Access Compliance Report

Public Rights-of-Way

(Pedestrian Signals)

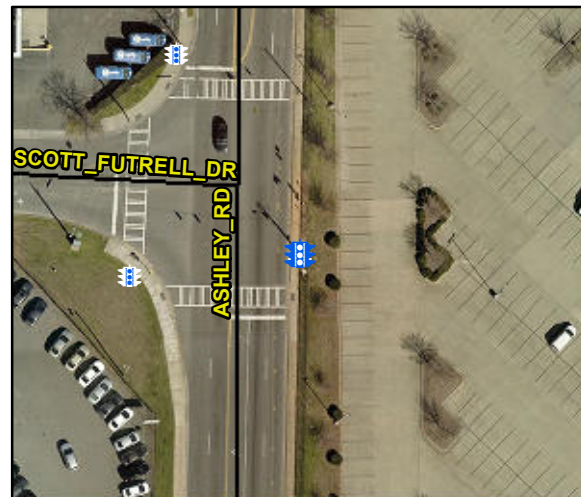
PROW/ADA: R209.1, TMUTCD 4e.08, R404.3, R404.1, R404.7.3, R404.7.2

N/A	B 1 Clear Xing Direction?	No	N/A	B 2 Clear Xing Direction?	N/A
	B 1 Crossing Direction	To W		B 2 Crossing Direction	N/A
No	B 1 DistanceTo XWalk (in)	174.0	N/A	B 2 DistanceTo XWalk (in)	N/A
Yes	B 1 DistanceTo Curb (in)	64.0	N/A	B 2 DistanceTo Curb (in)	N/A
Yes	B 1 Diameter (in)	2.0	N/A	B 2 Diameter (in)	N/A

Possible Solutions: Replace Signal Push Button With APS Button on New Post. Remove & Relocate Sign.
